IN THE DRAWINGS

REMARKS

ANNOTATED SHEET

FIG. 10D

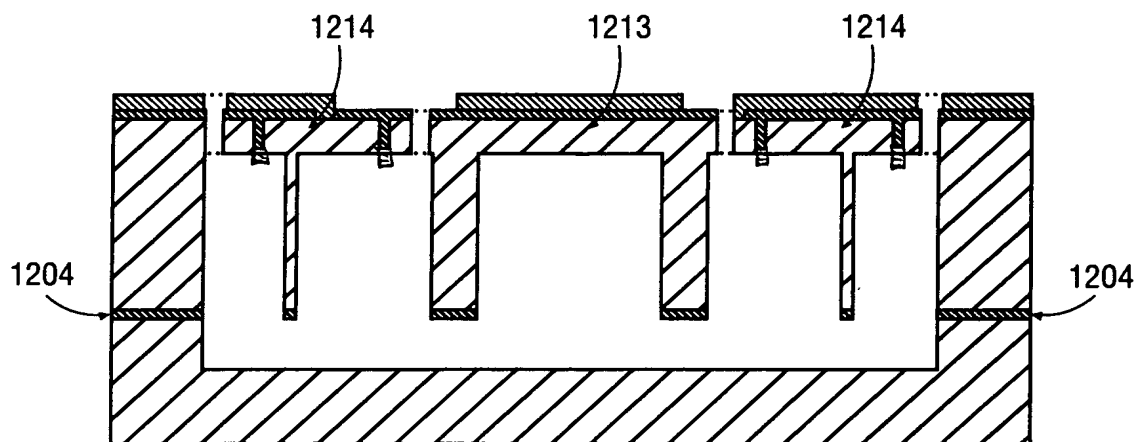
Annotated Sheets Showing Changes with respect to Figure 10D, 10E, and 12E of the drawings is provided with proposed change indicated in red ink. Corresponding Replacement Sheets are also enclosed. Applicants submit that the drawing as amended does not add new matter given that support is found in the originally filed drawings and in the specification at page 35, lines 1-5.

Figures 10D, 10E, and 12E have been amended to conform the formal drawings to the originally-filed drawings. Support for the corrections is found in originally filed Figures 10D, 10E, and 12E of the drawings.
